MODEL
Sportage (KM)

NUMBER
032

TECHNICAL SERVICE BULLETIN

SPORTAGE MUFFLER PIPE DRAIN

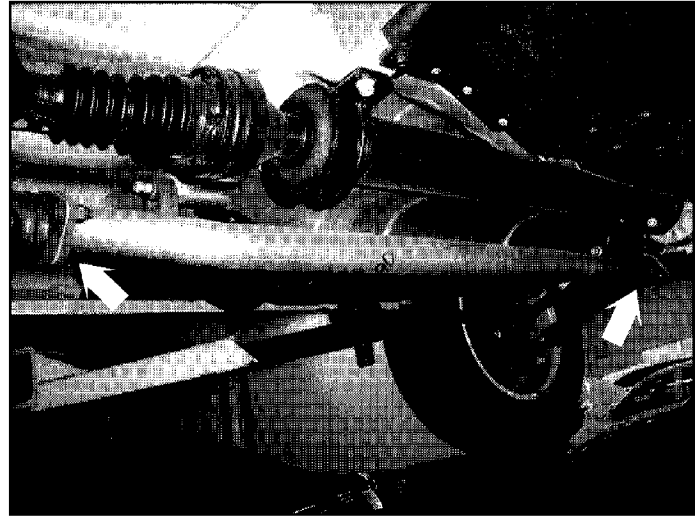
Shown in photo is ice accumulation in the muffler assembly exhaust pipe.

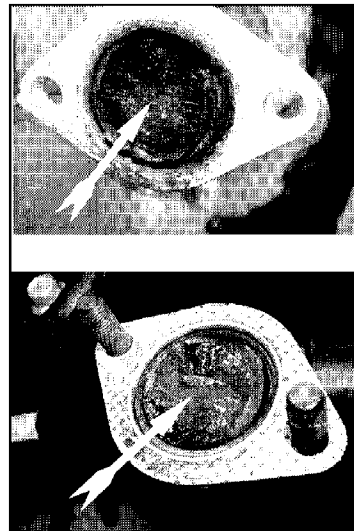
If the exhaust pipe is blocked by ice, remove ice prior to drilling a drain hole in the main muffler pipe.

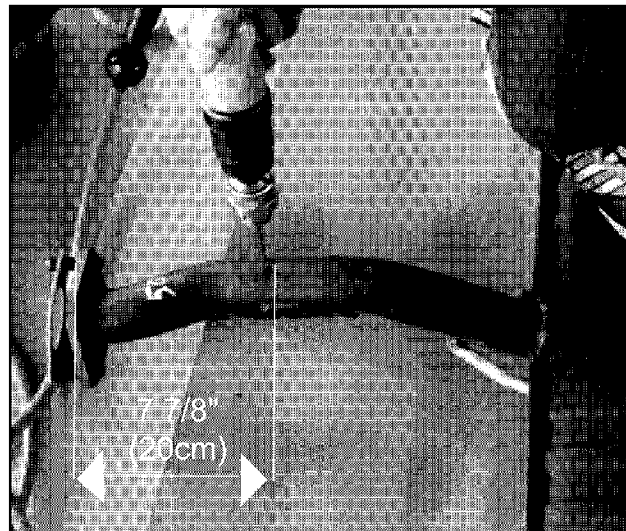
4. Measure and drill a 3mm hole on the bottom side of the main muffler pipe as shown.

Muffler pipes may be oval or round in configuration; the distance measurement shown is the same for both types.

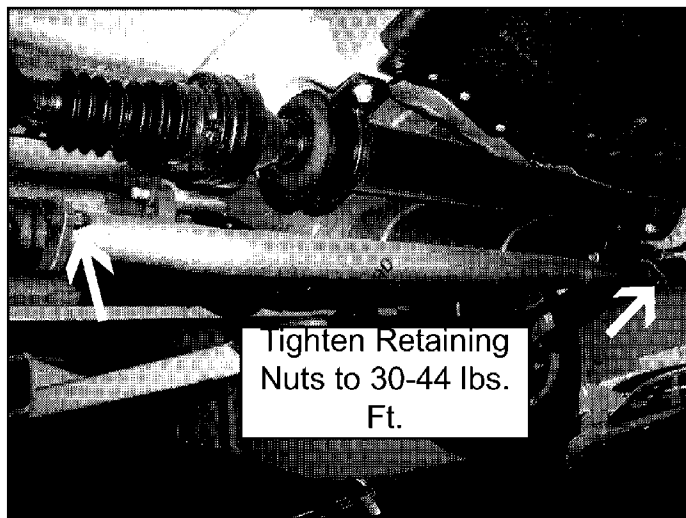
5. Install muffler assembly and intermediate pipe as required using new exhaust pipe gaskets. Tighten exhaust system retaining nuts to 30~44 lbs. ft. (40~60 Nm).
